## **Packet Guide**

BAR 21-09-04

301 East Jefferson Street, Tax Parcel 330204000

Project: Install lighting at Sanctuary entry

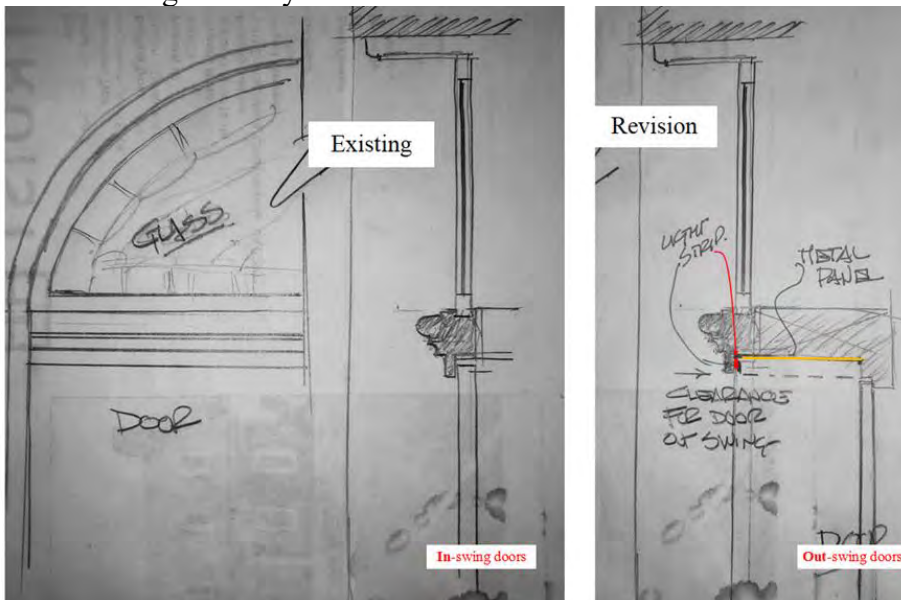
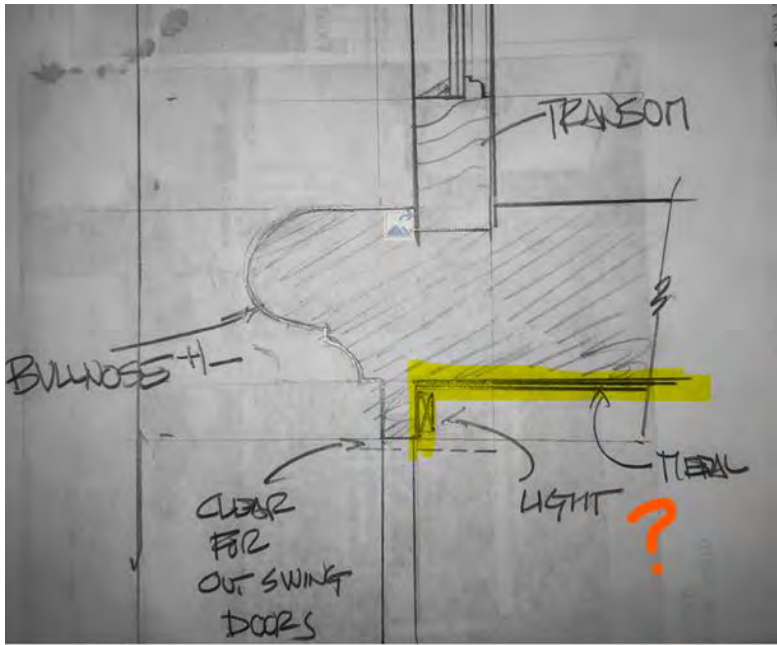
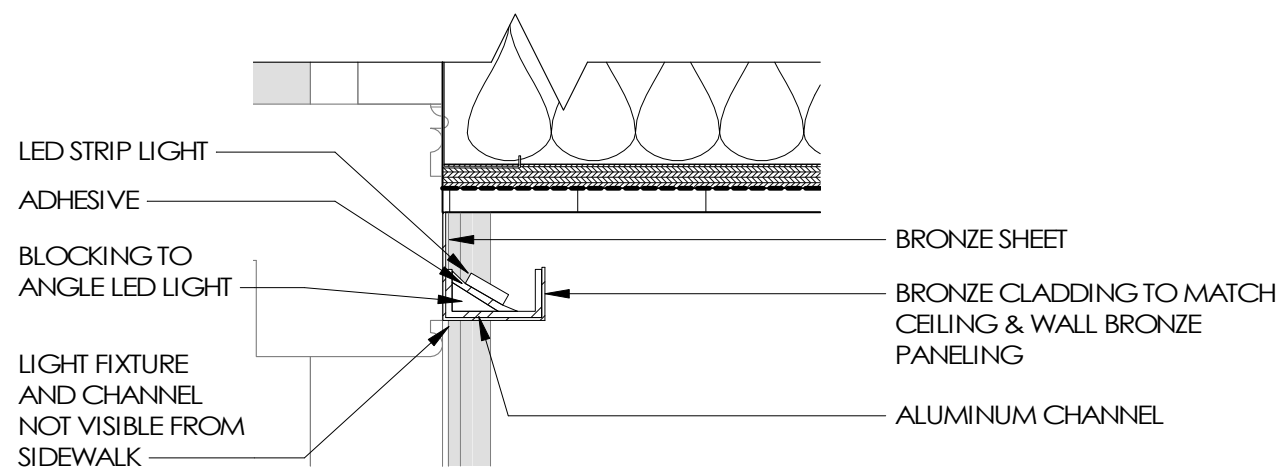
Staff: Forgive my rough sketches below. As I interpret your drawing plan, the head trim (the bullnose, exterior door stop, etc.) will remain in place, with the light strip fitting onto that door stop, more or less. Is that correct?

Applicant: Sketch is spot on. The light fixture is intended to be hidden from view from the street/front yard. The new door will be a bit shorter to make sure it can clear the existing jamb when it swings out as you have noted as well in the bottom sketch.

2 RIGHT SIDE ELEVATION

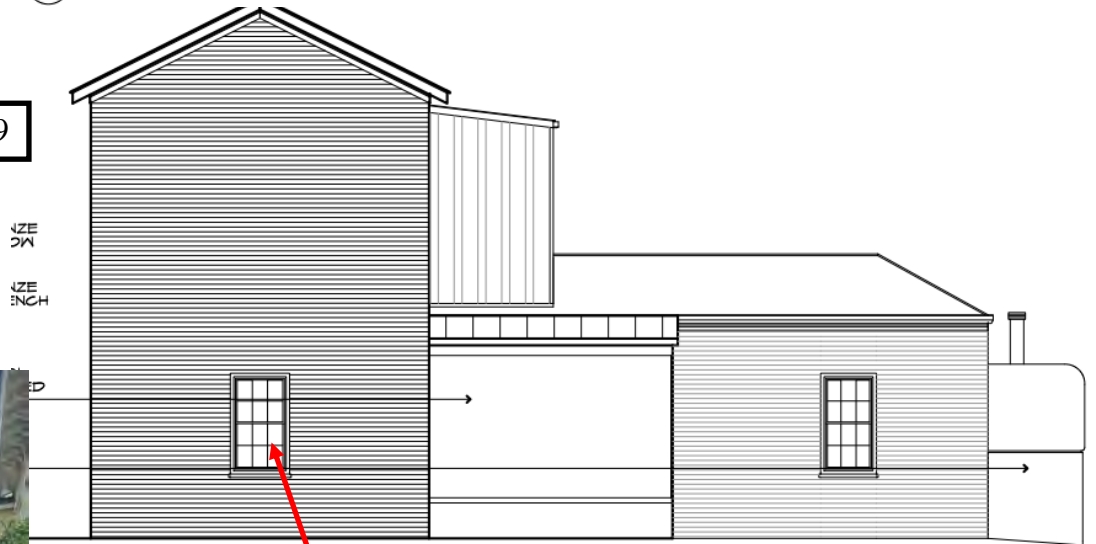
Staff note (9/2021): This window has already been removed. See staff report for discussion.

EXISTING REAR ELEVATION

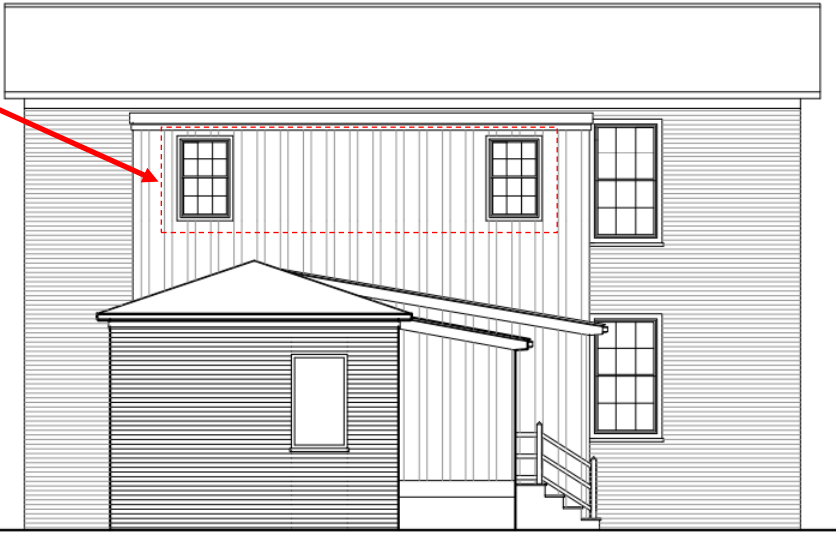
Staff note (9/2021): Windows shown incorrectly. Existing are single sash. (see below.)

See window note above. New windows to be 6-lite casement.
